REMARKS

This Amendment is filed in response to the Office Action dated August 28, 2002. A petition for a two-month extension of time is enclosed. Claims 1-7 and 9-20 are pending in this application. Claims 8 and 9 are cancelled, without prejudice.

Serial No. 09/617,459

FIG. 4

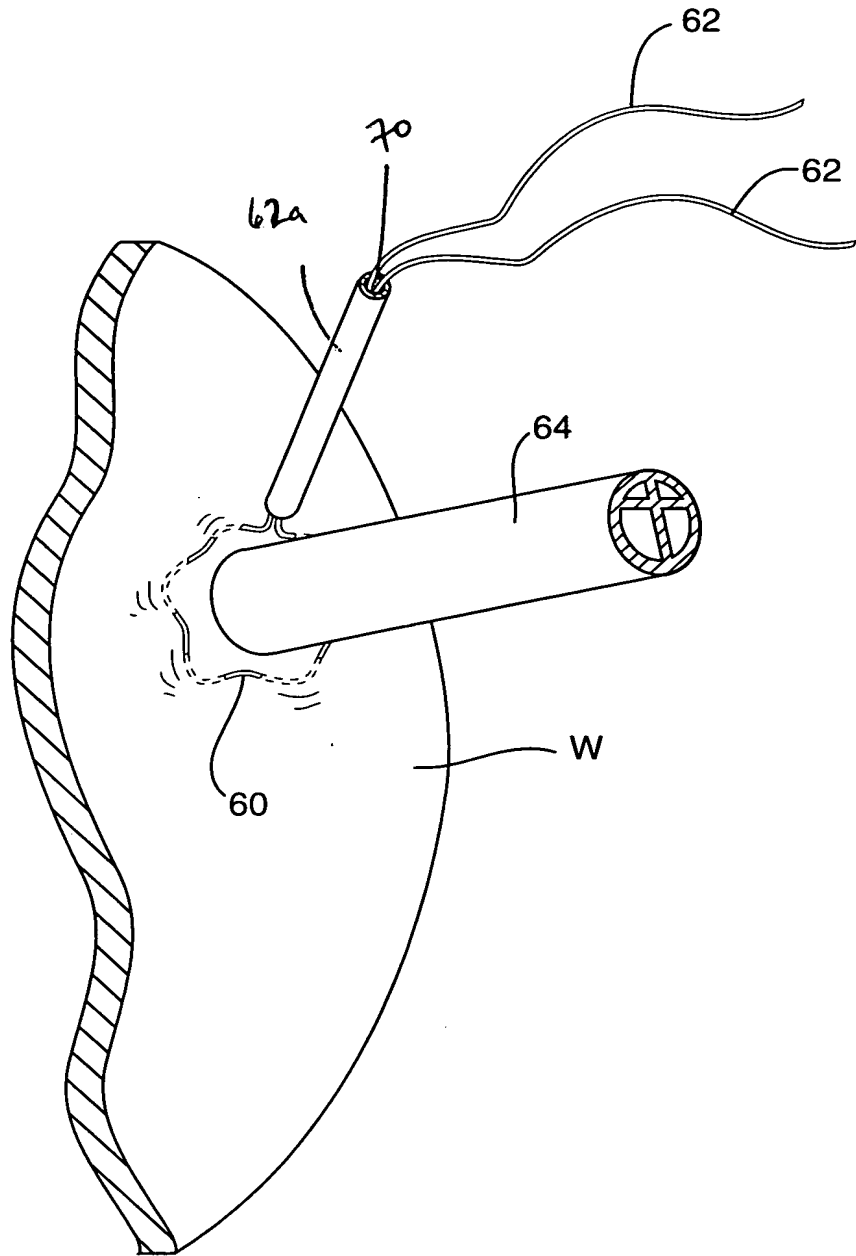
Further, Applicants have amended Figure 4 to include reference numerals 62a and 70 to correct an error located by the Examiner. A copy of the changes is indicated in red ink on an enclosed copy of Figure 4. Applicants will submit a formal drawing to make the proposed changes to Figure 4.
